Product Change Notice

PCN #: BE090220

Re: High Boost HAM

High Boost HAM

HAM Derating

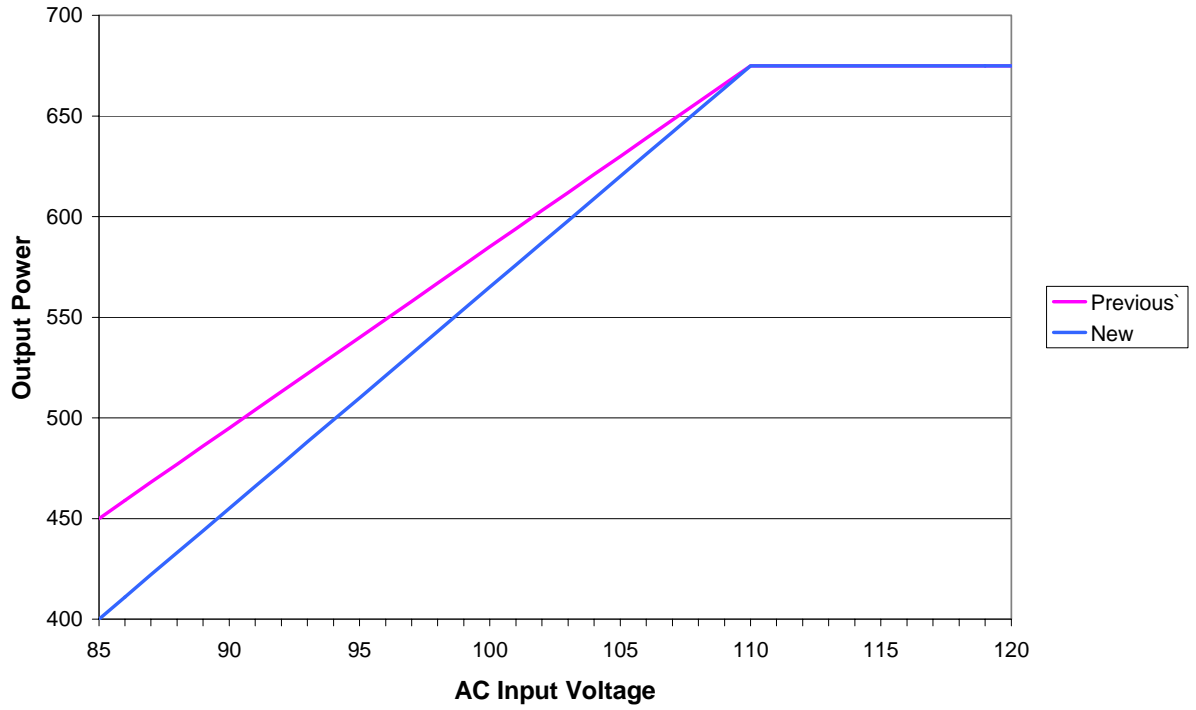
The high boost HAM power de-rating below 110Vac has been changed from 9 watts/Vac to 11 watts/Vac (see attached chart). This results in a power reduction throughout this range with the maximum reduction at 85Vac. At 85Vac, maximum power has been reduced from 450W to 400W.
